PCN Number:	20250204003.1	PCN Date:	February 05, 2025
Title:	Carrier Tape Change for select WQFN Package Device		
Customer Contact:	Change Management Team	Dept:	Quality Services
Proposed 1st Ship Date:	May 06, 2025	Sample requests accepted until:	Not applicable
Change Type:			
<input type="checkbox"/>	Assembly Site	<input type="checkbox"/>	Design
<input type="checkbox"/>	Assembly Process	<input type="checkbox"/>	Data Sheet
<input type="checkbox"/>	Assembly Materials	<input type="checkbox"/>	Part number change
<input type="checkbox"/>	Mechanical Specification	<input type="checkbox"/>	Test Site
<input checked="" type="checkbox"/>	Packing/Shipping/Labeling	<input type="checkbox"/>	Test Process
<input type="checkbox"/>		<input type="checkbox"/>	Wafer Bump Material
<input type="checkbox"/>		<input type="checkbox"/>	Wafer Bump Process
<input type="checkbox"/>		<input type="checkbox"/>	Wafer Fab Site
<input type="checkbox"/>		<input type="checkbox"/>	Wafer Fab Material

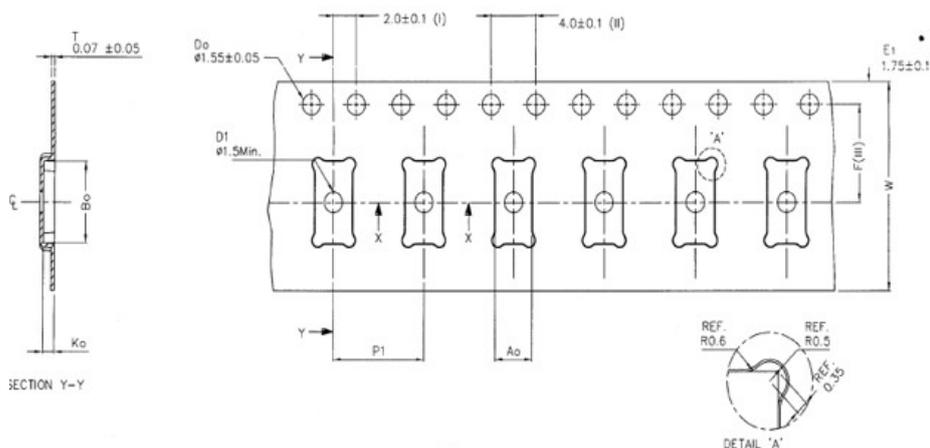
Texas Instruments is pleased to announce the qualification of a new carrier tape for select WCSP Package Device. The material composition between the 2 carrier tapes is the same. A dimensional comparison summary is below:

Carrier tape Dimensions:

Dimension	From	To
Part No.	SID 26080143	SID 26020494
A0	3.30 (+/- 0.10) mm	3.30 (+/- 0.10) mm
B0	6.30 (+/- 0.10) mm	6.30 (+/- 0.10) mm
K0	1.05 (+/- 0.10) mm	1.00 (+/- 0.10) mm
W	12.00 (+0.3/- 0.1) mm	16.00 (+0.3/- 0.1) mm

Current Design:

Proposed Design:
